COMMENT ON WATER AND SANITATION CAPACITY FOR THE PROPOSED MIXED USE DEVELOPMENT- FARM 845- SIR LOWRY'S PASS VILLAGE

Background

This is a revised comment on water and sanitation infrastructure capacity. This comment covers the change in the number of units and the proposed phasing of the development. Developer has decided to increase the density of the development from 600 units to 1000 units and added a 3.69 Ha of mixed development. The developer has also proposed phased implementation.

Figure 2a: Sewer Downstream Constraints

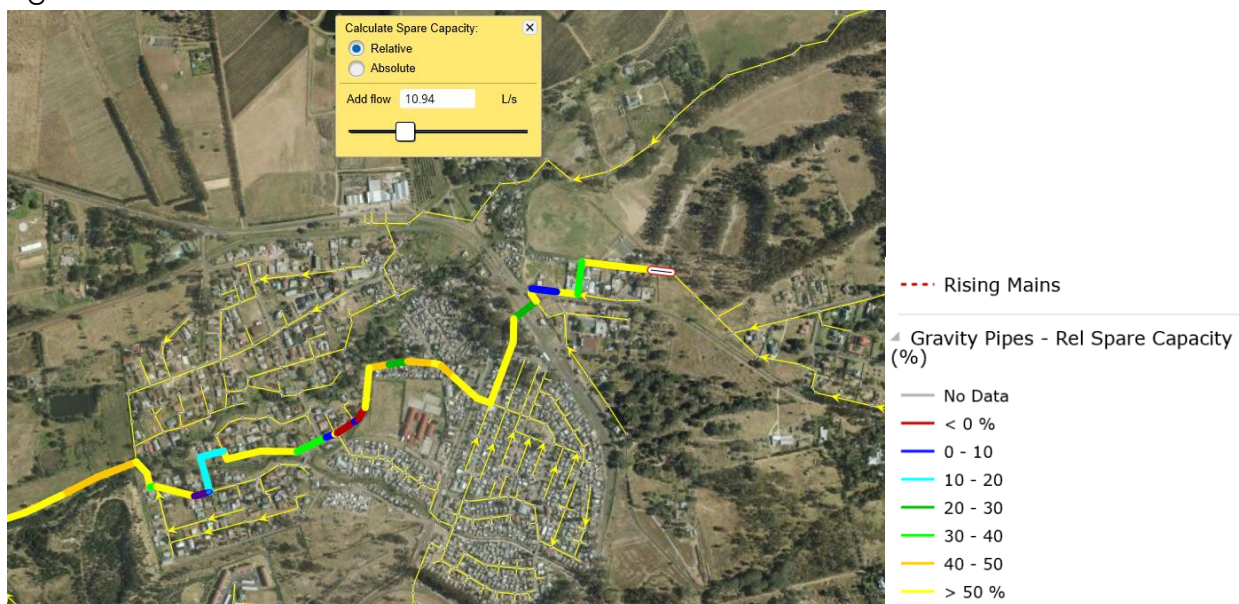
The City's sewer network model indicates a 150mm Ø gravity sewer main along Khorhoek road next to the proposed development. The impact of loading the sewer from the development will have an impact on the downstream system (See Figure 2a). There downstream segments that show capacity constraints where surcharging of the sewer can be expected. As pointed out in the background paragraph this area is not a priority development area for the city and all upgrades in the sewer system will be to the cost of the developer.

The developer has proposed phasing the development to reduce the immediate load on the sewer reticulation system. The existing downstream sewer can only accommodate maximum of 3 l/s peak flow. Development that generates flows above 3 l/s will require upgrading the sewer collector downstream of the development along Brinkhuis Road and up stream of Mission Street.

Figure 2a below reflects the downstream constraints in the system.

1. Development Contributions is payable as per the DC policy.
2. The water supply does not have sufficient pressure to reach the highest point in the development, storage and or boosting may be required.
3. The developer is required to show all water saving interventions in the development.
4. The downstream sewer network has constraints and can accommodate a maximum of 3 l/s peak. Sewer network will have to be upgraded for flows above this threshold.
5. The required link services are to be installed prior to the occupation of any dwelling.
